[Docket No. 99-SW-08-AD; Amendment 39-11657; AD 2000-07-03]

Airworthiness Directives; Robinson Helicopter Company Model R44 Helicopters

AD 2000-07-03 Robinson Helicopter

FIGURE 1

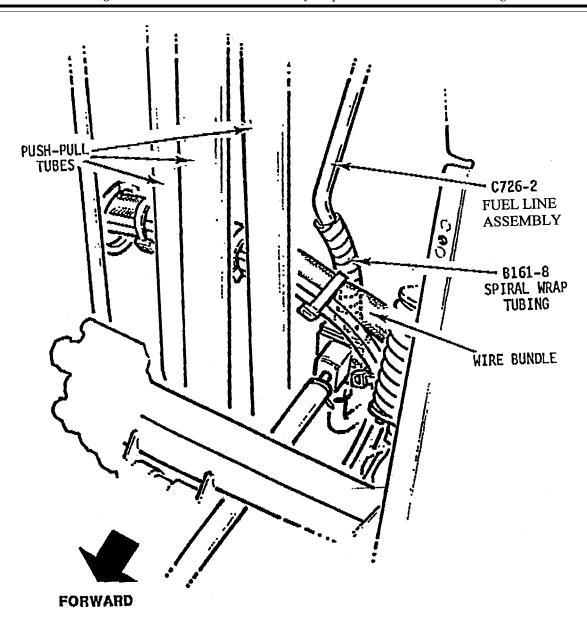
- (a) Remove the cover, part number (P/N) C474–1, from between the rear seatbacks.
- (b) Inspect the wire harness, P/N C059, and the fuel line assembly, P/N C726–2, above the fuel shutoff valve for contact. If the wire harness contacts the fuel line assembly, inspect for chafing.
- (c) If chafing has occurred between the wire harness and the fuel line assembly, replace the fuel line with an airworthy fuel line assembly. Torque the fuel line nuts to 110–130 in-lbs. Verify that clearance exists between the fuel line assembly and the wire harness.
- (d) Install a 3-inch section of spiral wrap tubing, P/N B161–8, on the fuel line assembly as shown in Figure 1. Push the spiral wrap tubing down until it is against the fuel line fitting.
